Product / F	Process Change Notificati	on (PCN)		
PCN #:	PCN_WCAP-ASLI_20220421	Change Category:		
Affected Series:	WCAP-ASLI	□ Equipment / Location☑ General Data□ Material		
PCN Date:	January 21, 2022	□ Process		
Effective Date:	April 21, 2022	□ Product Design□ Shipping / Packaging□ Supplier□ Software		
Contact:	Product Management	Data Sheet Change:		
Phone:	+49 (0) 7942 - 945 5001	⊠ Yes □ No		
Fax:	+49 (0) 7942 - 945 5179	Attachment:		
E-Mail:	pcn.eisos@we-online.com	☐ Yes		
DESCRIPTION AND	PURPOSE OF CHANGE:			
Because of a database mismatch, Würth Elektronik will update all datasheets for the Matchcode WCAP-ASLI. The component Marking will be changed to the current state of art.

DETAIL OF CHANGE:

Datasheet Update

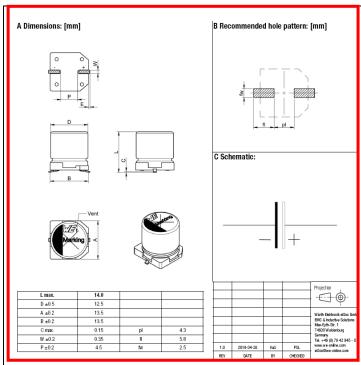
Würth Elektronik will update the datasheet layout in general for all WCAP-ASLI datasheets. Furthermore with this layout update Würth Elektronik will correct the electrical and mechanical characteristics. All corrections in terms of electrical characteristics are shown below. They will also be clearly visible in the new datasheets which Würth Elektronik will provide on the website shortly.

Example for drawings with indirect dimensioning

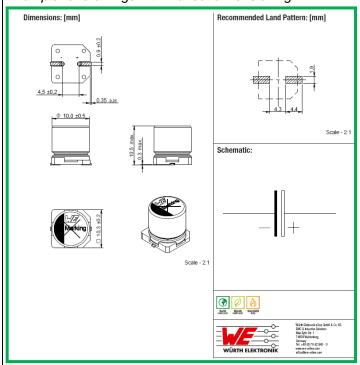
• All corrections in terms of mechanical characteristics are shown. In order to visualize the corrections of the dimensions example of the old and the new drawings is shown below. Würth Elektronik will update the dimensioning from an indirect dimensioning to a direct dimensioning:

In the course of the update from indirect to direct dimensioning the values for the dimensions and tolerances will be updated. The upcoming corrections can be seen more detailed in the pictures above.

Example for new drawings with direct dimensioning
